**TRUE VISION CHURCH
Kirby, Texas**

ADDENDUM NO. 2

Sheet A8.21 – Sanctuary Floor Finish Plan – Main Level

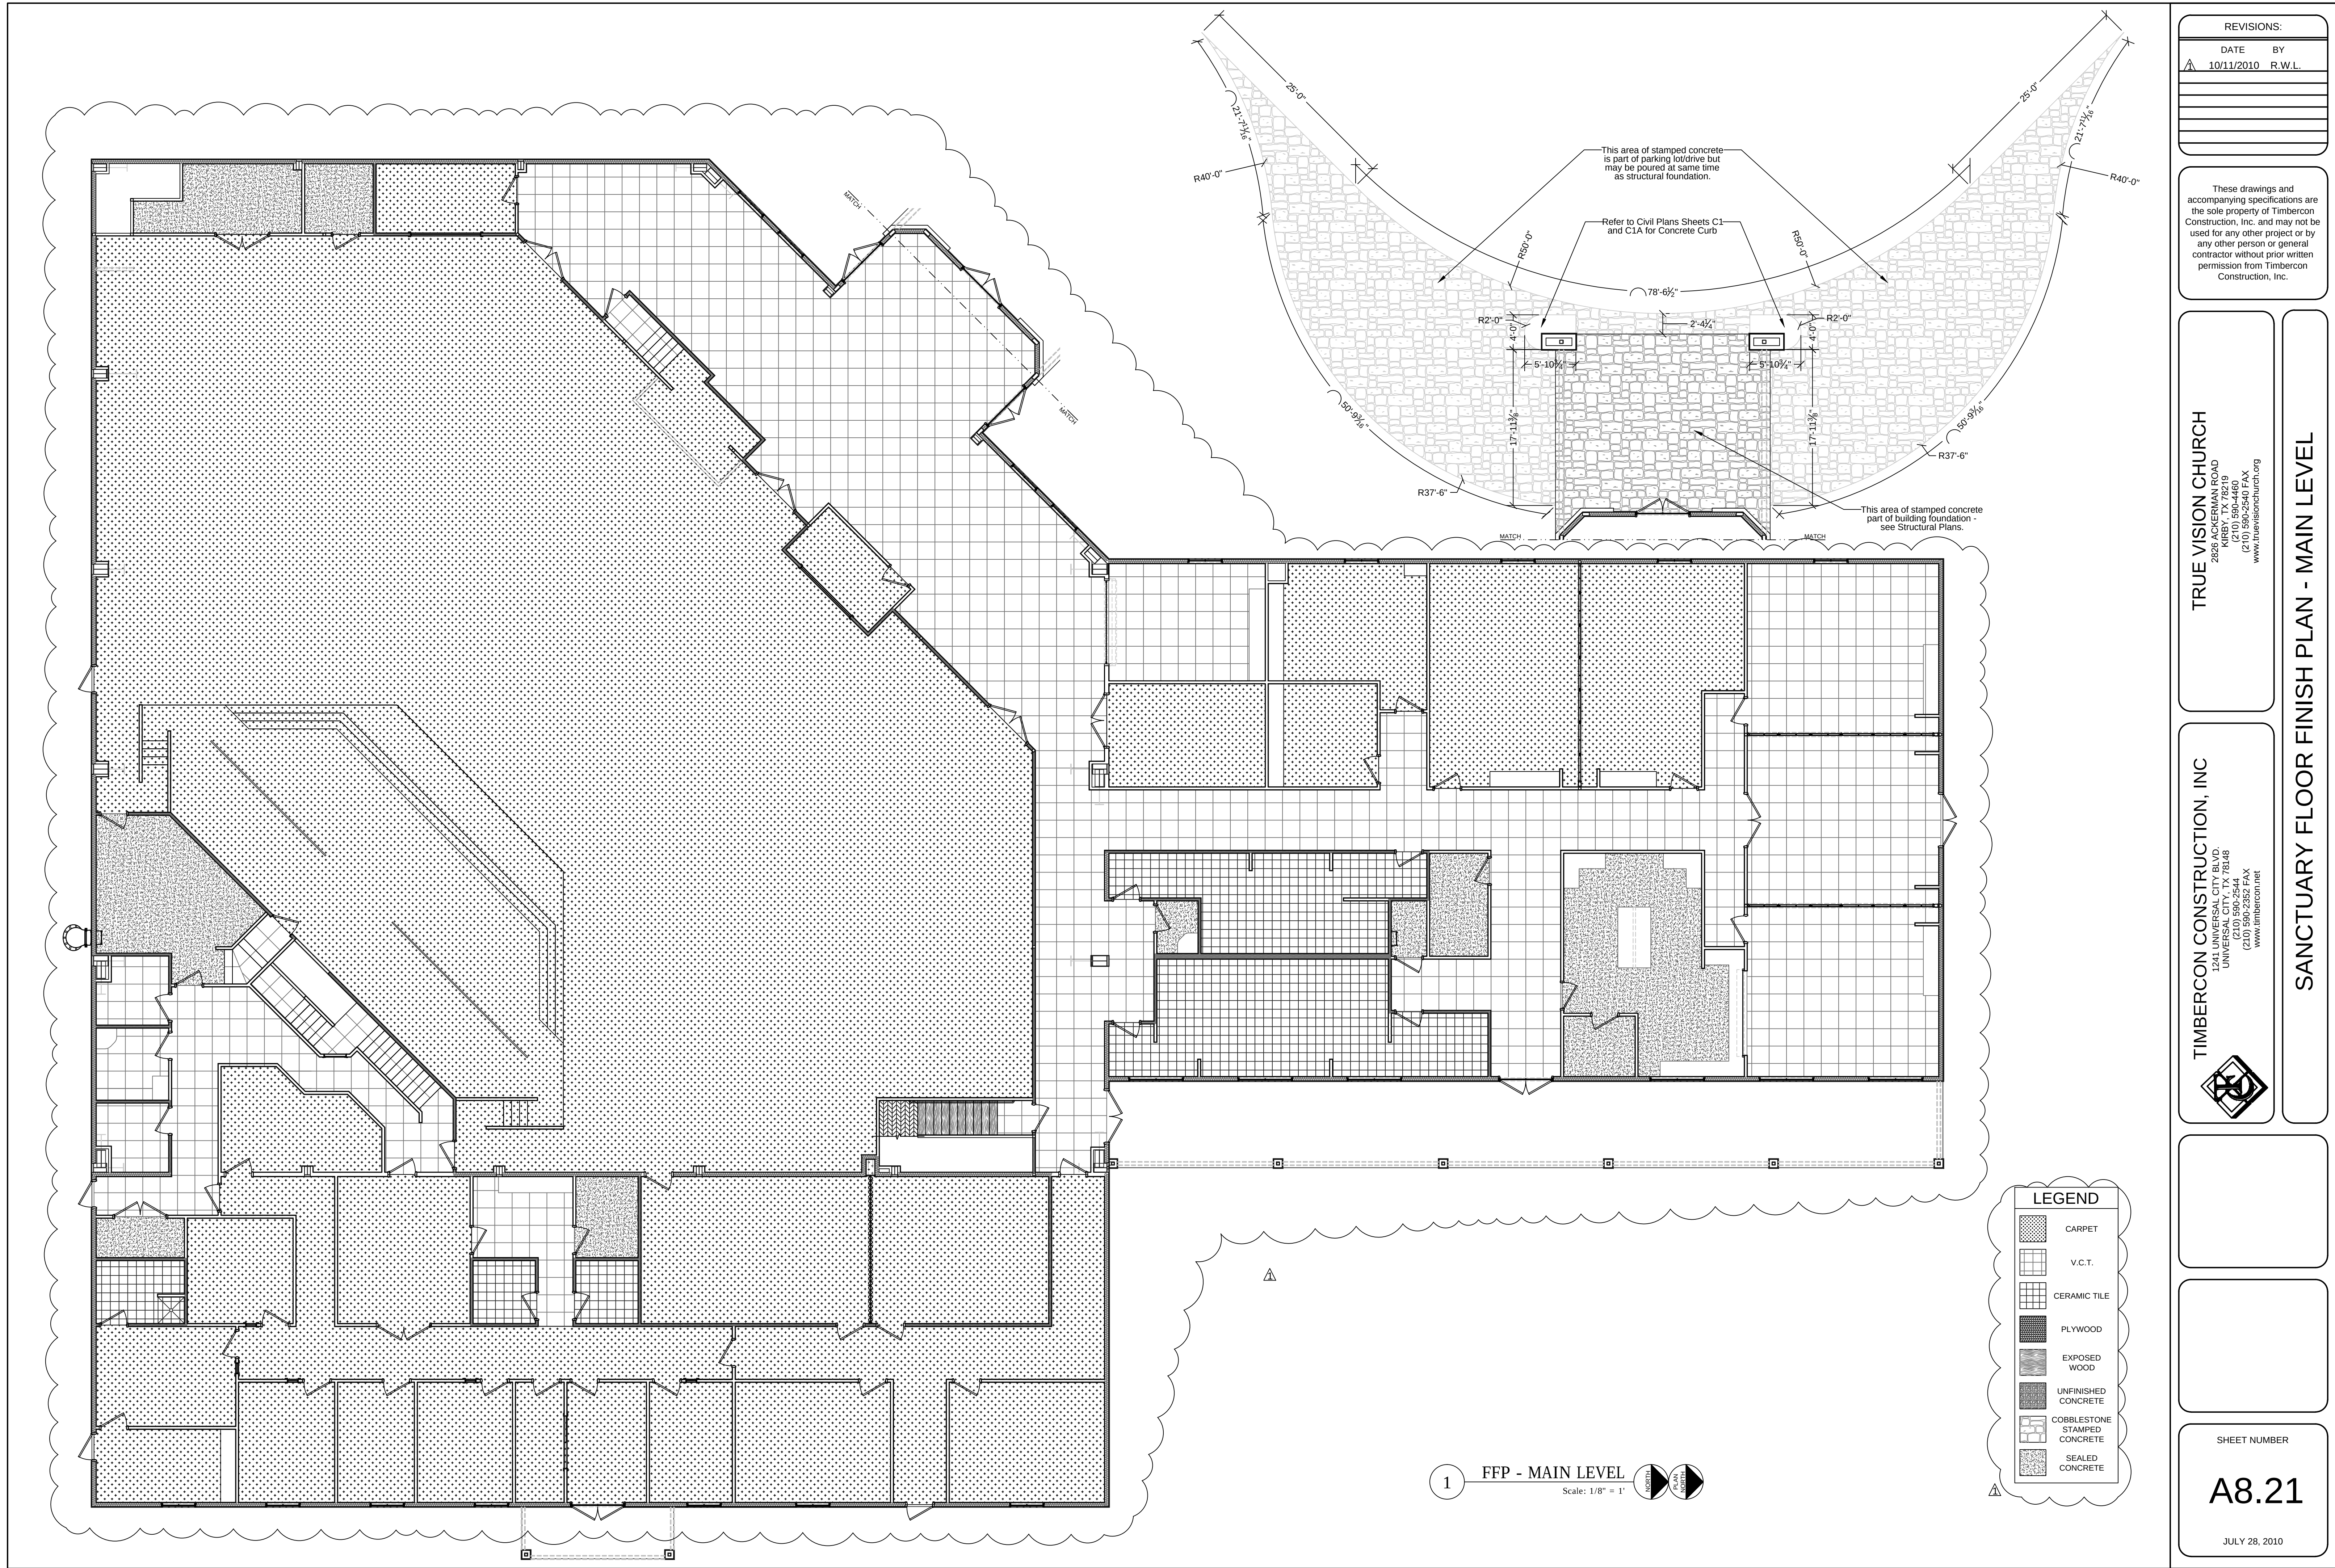
Drawings – The following sheets have been revised. Floor finishes have been updated so that the drawings and the plans now correspond to each other:

SANCTUARY FLOOR FINISH PLAN - MAIN LEVEL (ALT. 1)

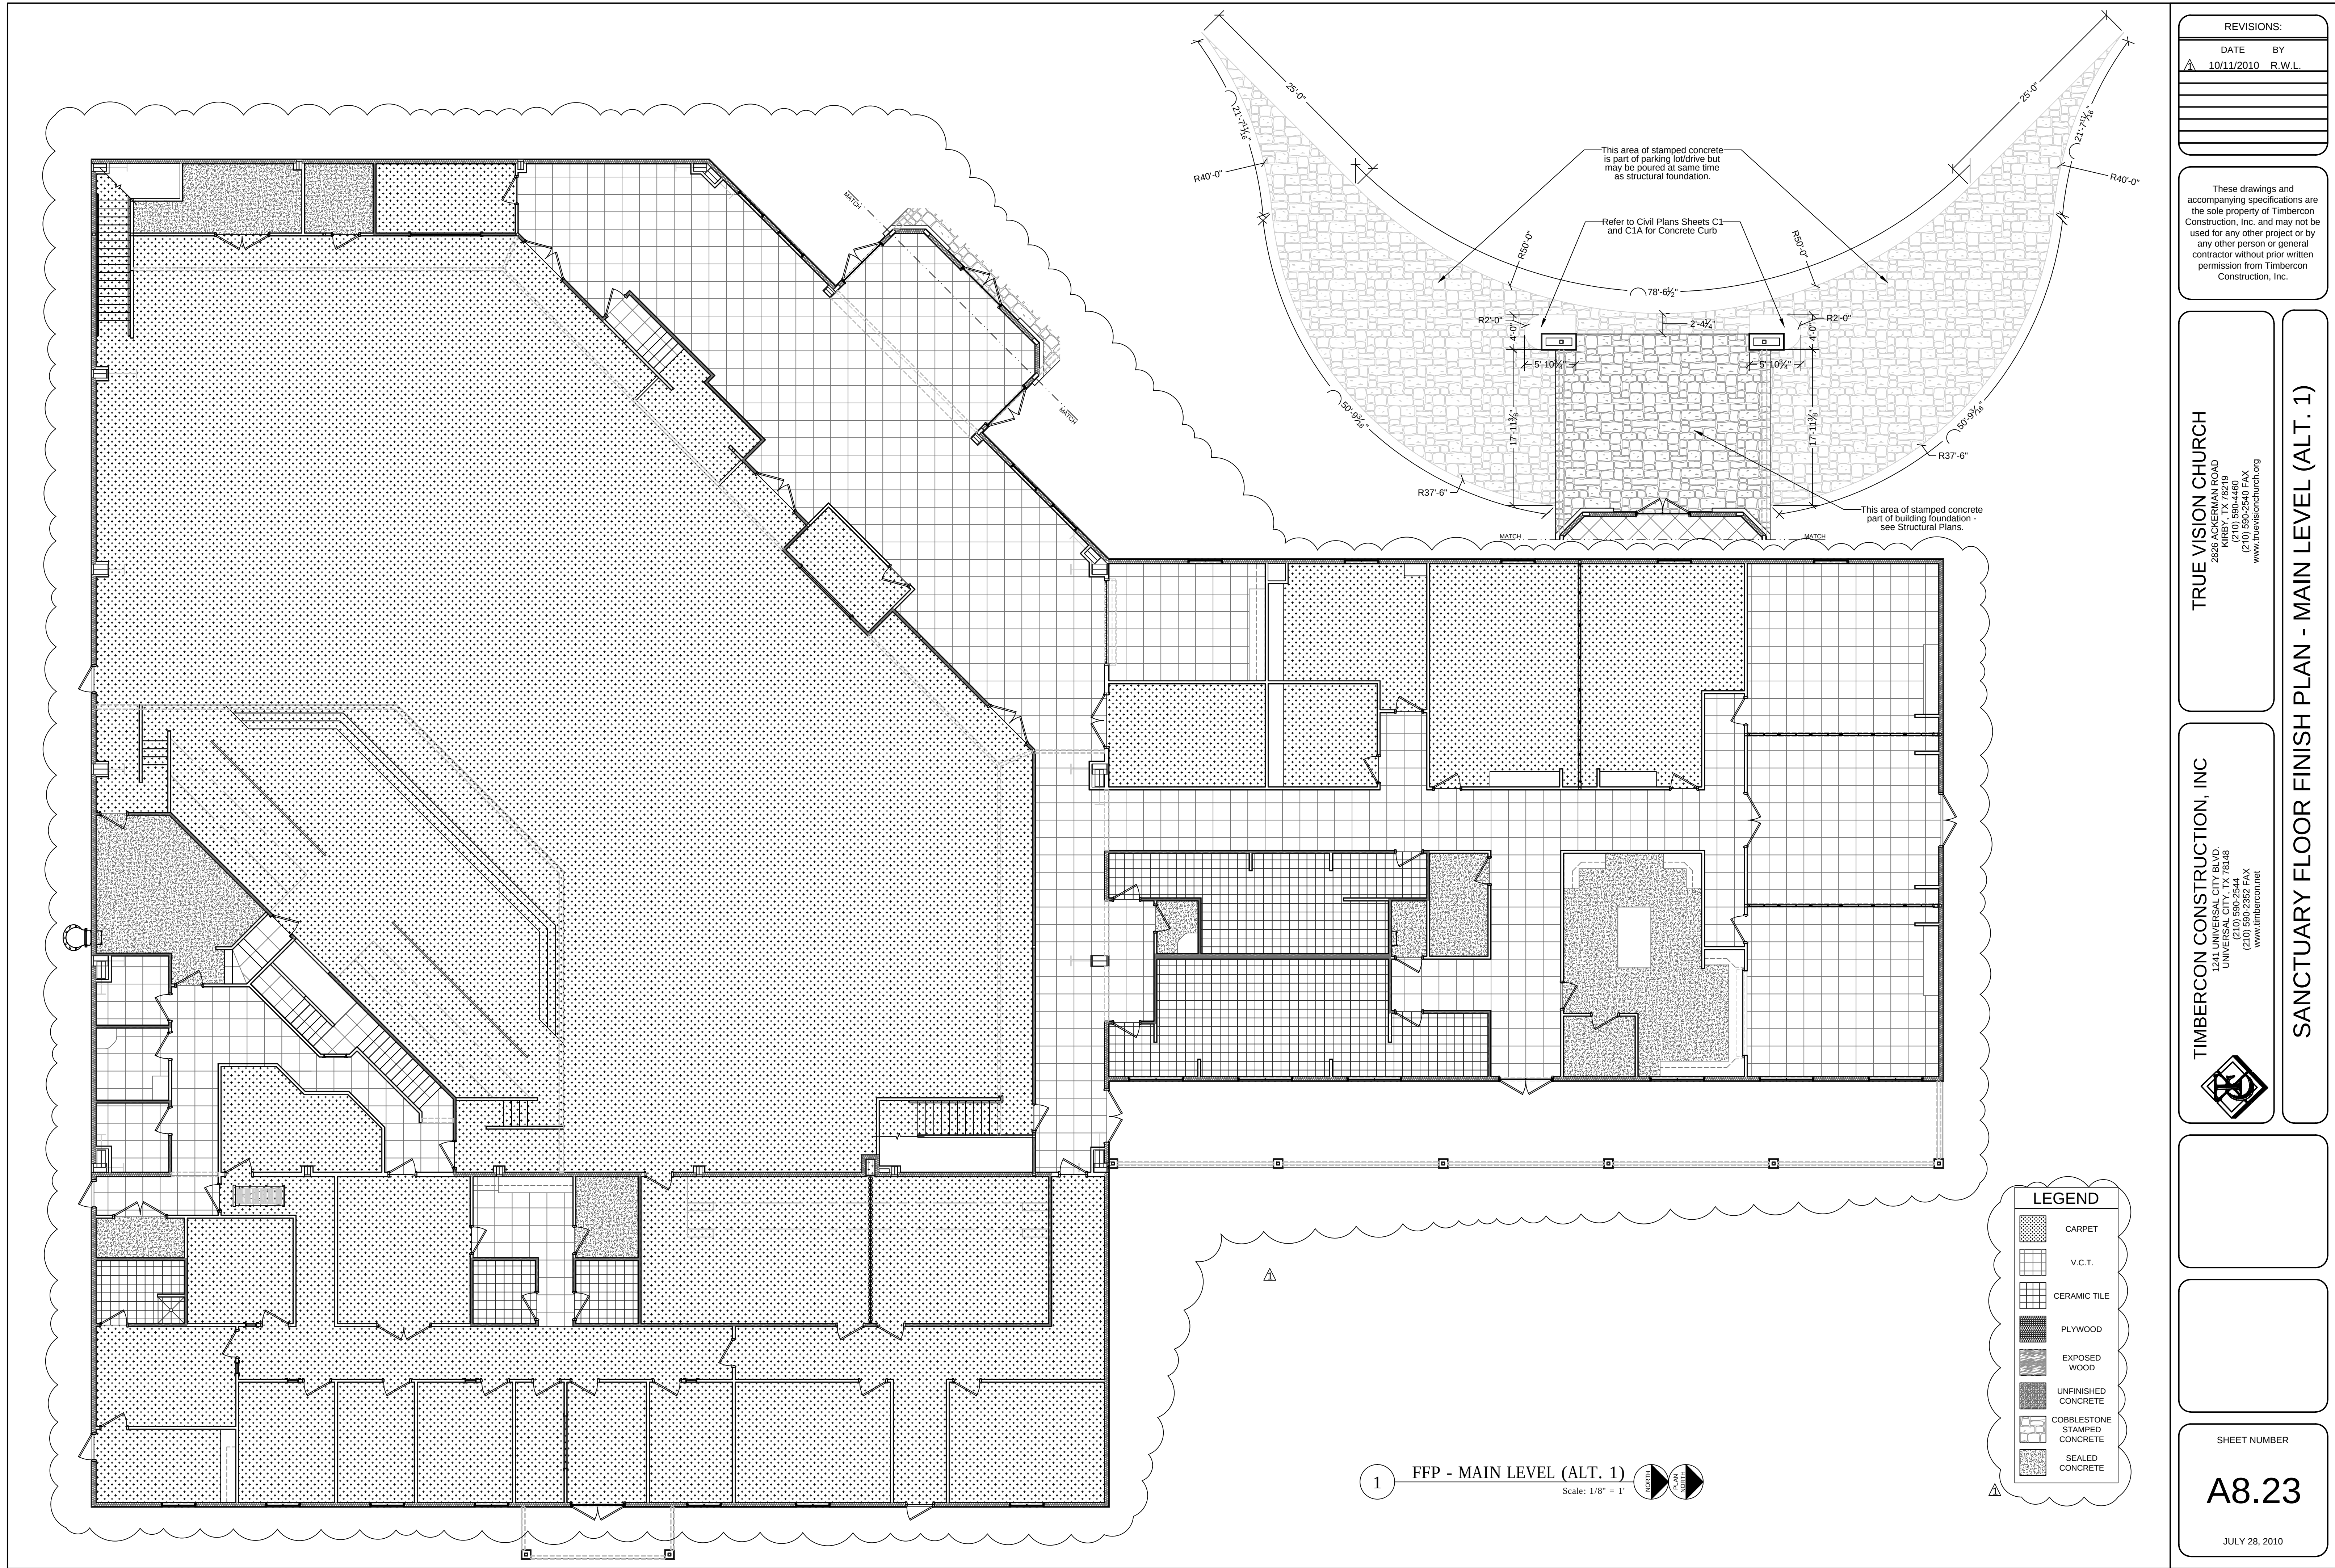
Sheet A8.23 – Sanctuary Floor Finish Plan – Main Level (Alt. 1)
